# Accu-Chek® Inform II

## **Supplement to the Operator's Manual v7**

*Amendments to Operator's  
Manual v7*

This document provides a description of changes to the Operator's Manual V7 for SW 04.04.00.

#### **Docked screen - meter status**

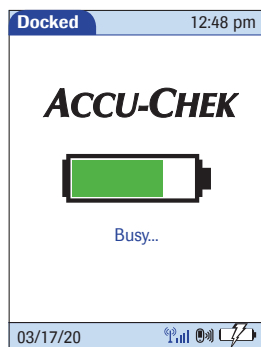
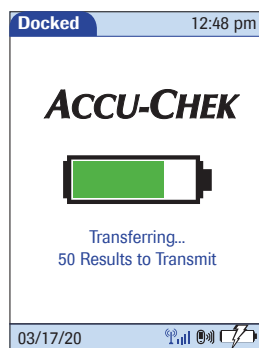
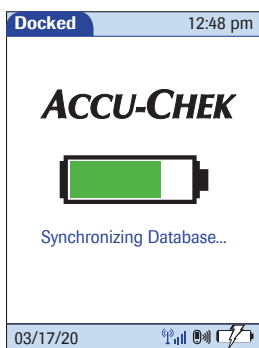
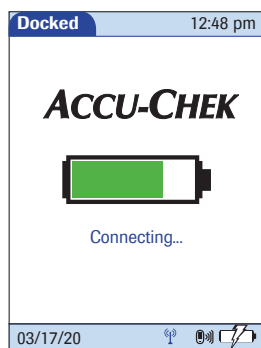
The following information will be **added** on page 130:

When docked, the meter shows different messages according to the current meter status.

The following displays appear on the meter when it is **docked** in an Accu-Chek Inform II Base Unit or an Accu-Chek Inform II Base Unit Light **and communicating**. The same displays appear whether the meter is transferring data via base unit or via wireless connection.

This display is visible when communication is still active but the meter is busy processing the data received or waiting for the next data message from the DMS.

While being docked and recharging the meter regularly checks the time since the last maintenance reboot. After at least 24 hours another maintenance reboot will be initiated. During this maintenance reboot the integrity of stored data and the function of the measurement module will be checked. Additionally the system searches for outdated results which can be deleted, because the configured retention time for these records has elapsed.
